Product Change Notification

Vishay Thin Film G Termination M Series Manufacturing Site Change

PCN Number: PCN-TF-006-2015 Rev 0

LAYOUT AND DIMENSIONS

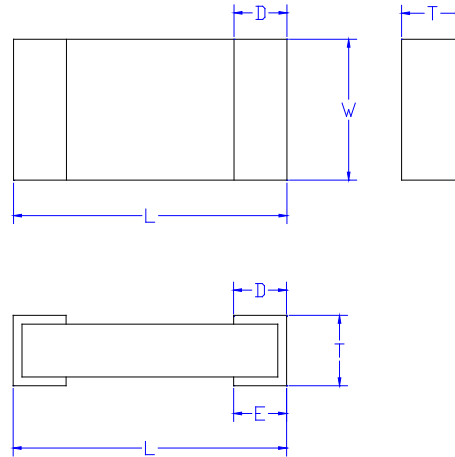
Chip Dimensional Changes: Differences in length, thickness and top and bottom termination pad dimensions are identified in the tables below.

Current Length (L")	New Length (L")	Current Thickness (T")	New Thickness (T")
0.050 ±0.006	0.055 ±0.005	-	-
0.050 ±0.006	0.055 ±0.005	0.0120 Max	0.020 ± 0.005
0.209 ±0.009	0.197 ±0.006	-	-
0.259 ±0.009	0.250 ±0.006	-	-

Case Size	Current Top Term (D")	New Top Term (D")	Current Bottom Term (E")	New Bottom Term (E")
M-0502	-	-	0.010 ±0.005	0.015 ±0.005
M-0603	0.010 ±0.005	0.012 ±0.005	0.010 ±0.005	0.015 ±0.005
M-1005	0.015 ±0.005	0.020 ±0.005	0.015 ±0.005	0.020 ±0.005
M-1505	0.015 ±0.005	0.020 ±0.005	0.015 ±0.005	0.020 ±0.005
M-2010	0.020 ±0.005	0.015 ±0.005	0.020 ±0.005	0.015 ±0.005
M-2512	0.020 ±0.005	0.015 ±0.005	0.020 ±0.005	0.015 ±0.005
